# LiDAR Quality Assessment Report

SD\_MtRushmore-RileyPass\_2012

Mount Rushmore NM and Riley Pass, Cu...

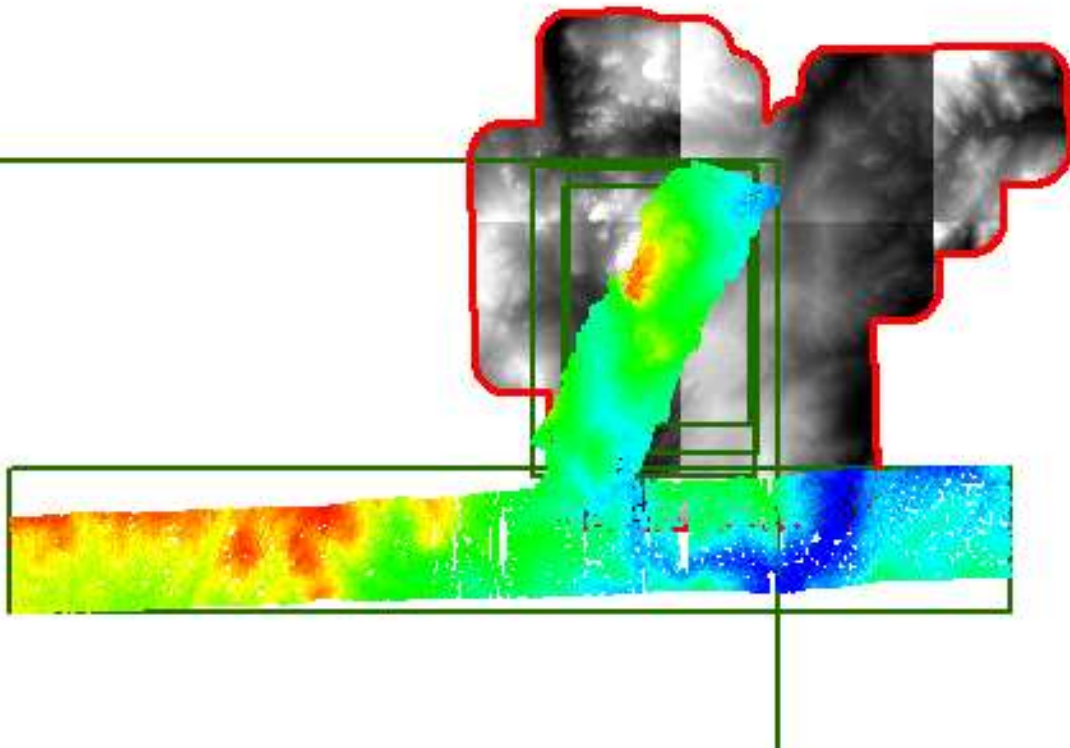
Do not have a complete delivery of swath files for Mt. Rushmore area. The

Rushmore\_Raw\_Strips are the E-W swath row and the Monument\_Special\_Raw are the swath files oriented NE-SW. The swath data does not cover the DEM area and an FVA of the swath cannot be checked at NGTOC at this time.

**\*\*Vendor fixed this issue\*\*** 1/17/2013 See picture at bottom of this section. FVA was calculated on the swath data with a result of 7.9 cm. Text file of report is located in the NGTOC\_Created\_Metadata folder.

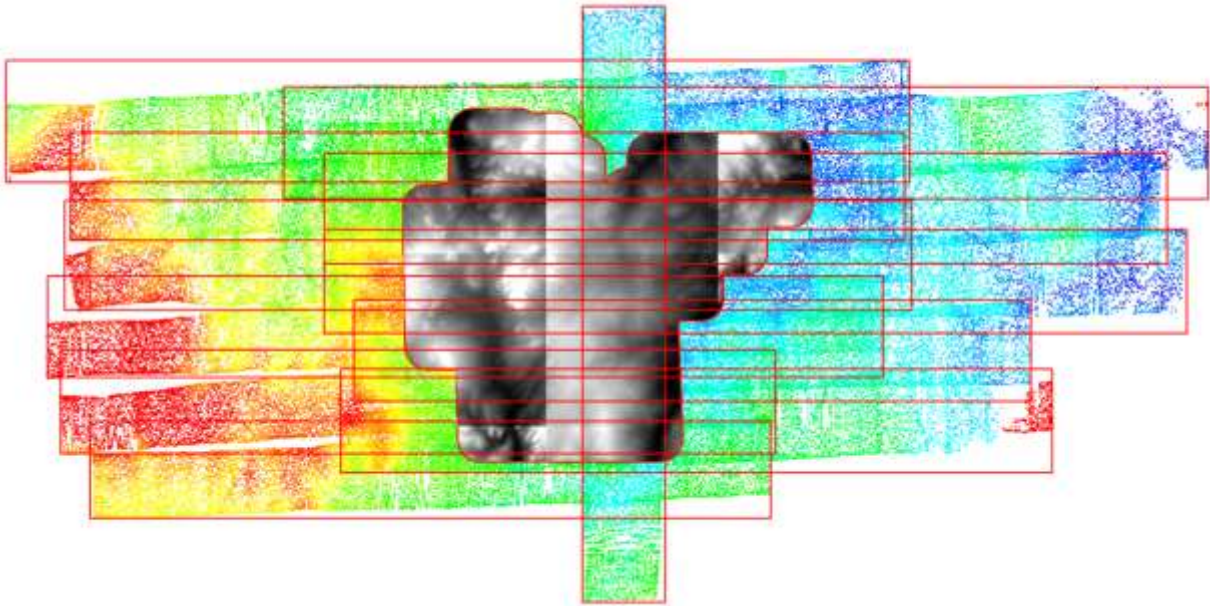
Resulting shapefile from Point Cloud Statistics on the raw .las for Mt. Rushmore. The large box showing is from the 17.las file (Monument\_Special\_Raw) which has a point in the lower left corner (see picture below).

In the 17.las file of the Monument\_Special\_Raw folder is a point far from the monument area of collection.

**\*\*Not corrected by vendor\*\*** 1/17/2013. Per CPT - This data is not a task order requirement, it is extra data delivered by vendor. Therefore, this does not affect the recommendation of the data for NED. Vendor will be made aware of issue, but this special swath data will be delivered as is.
